Form WMSC-IR-1

Washington Metrorail Safety Commission

Incuration Data	YYYY	MM	DD	Report Number	20210422 \\/\\\\\\\\\\\\\\\\\\\\\\\\\\\\\\\\\					
Inspection Date	2021	04	23	Report Number	20210423-WMATA-LBW-1					
Rail Agency Name	Washington Metropolitan Area Trans Authority			Rail Agency Department	Operations	Sub- Department		Vehicles		
	1	Name		Email	Office Phone		Mobile Phone			
Rail Agency Department Contact Information										
Inspection Location	Alexandria Yard – Tracks 23 and Track 24

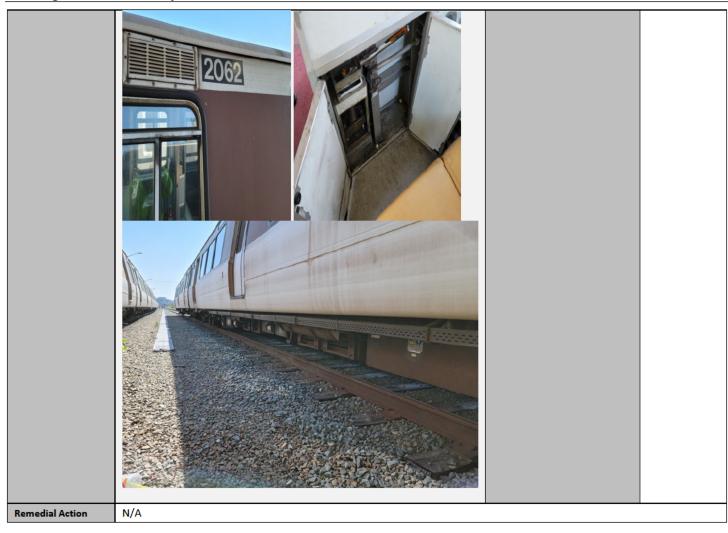
During this inspection of Alexandria Yard, the WMSC inspector observed Class I vehicles stored without handbrakes, wheel chocks or blue flagging protection. This is a violation of the requirement as written in the rule. This requirement needs to be emphasized to all responsible personnel for compliance, at all applicable Metrorail yards, to prevent repeat observations of the same noncompliant condition, noted here.
